# PERMIT

SEWAGE DISPOSAL SYSTEM

SUBDIVISION Hallmark ROAD 7371 Hallmark Road LOT 27, Sec. 2

## SEWAGE DISPOSAL TESTING

Lot. 27 Hallmark

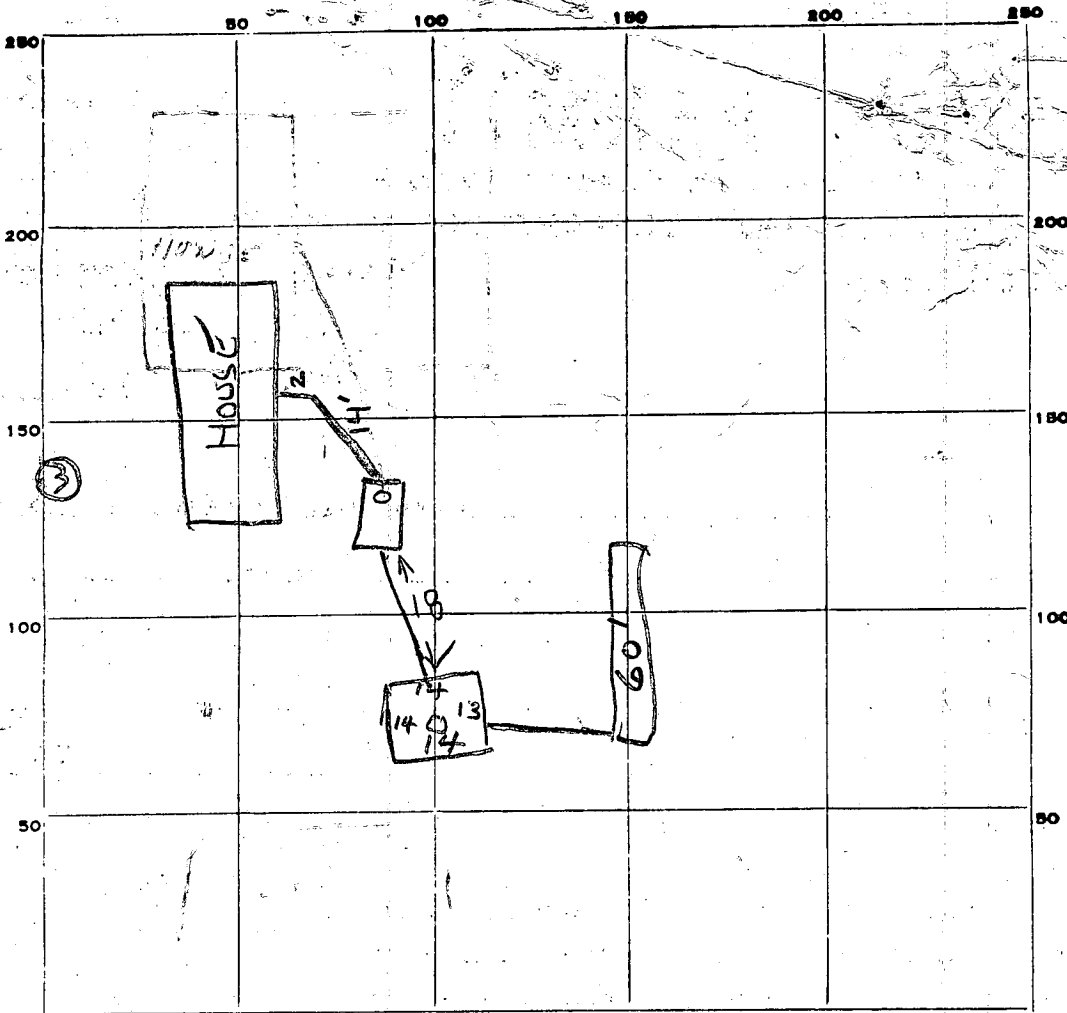
Needs well cap replaced 6 Sept 78  
Well cap replaced 10 Sept 78

26 JULY - OK TO LAY CAST IRON PIPE, WITH CLEAN OUT. GRAVEL IN

DRY WELL & TRENCH - CALL FOR INSPECTION JS

31 July 78 - Cover all work. System not approved until house connection made. Call for final. (GLK)

6 Sept 78 - House connection installed. However, well cap is broken and needs to be replaced before final approval given. (GLK)

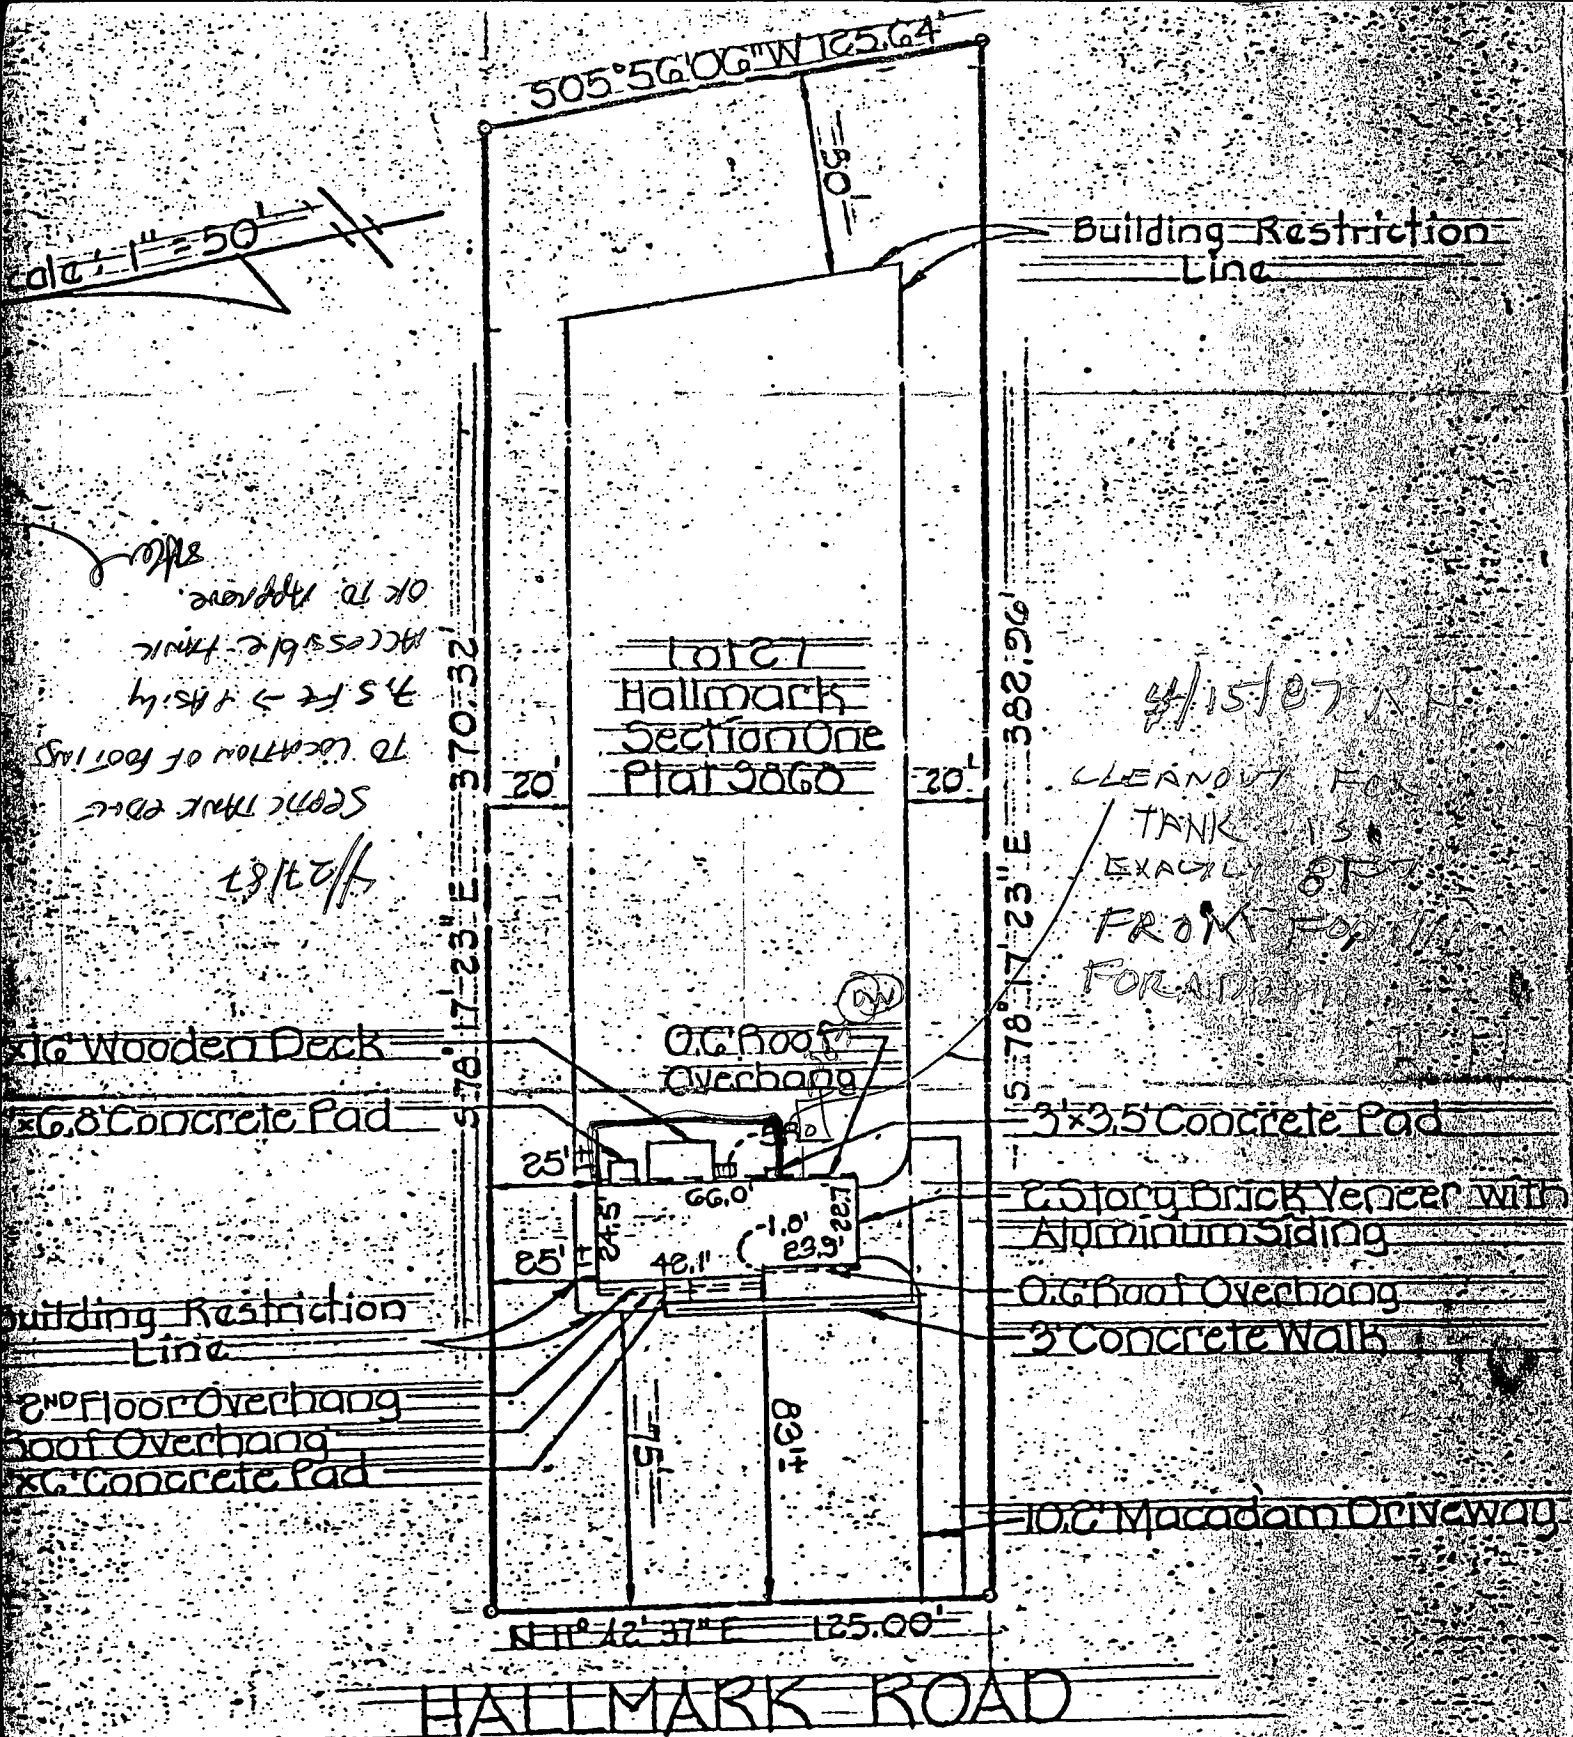
OK TO APPROVE  
 ACCESSIBLE DRIVE  
 7.5 FT → 4.5 ft  
 TO LOCATION OF FOOTING  
 SEE PLAN THAT DATE  
 12/11/87

4/15/87  
 CLEAROUT FOR  
 TANK IS  
 EXACTLY 8 FT  
 FROM FRONT  
 FOR APPROVAL
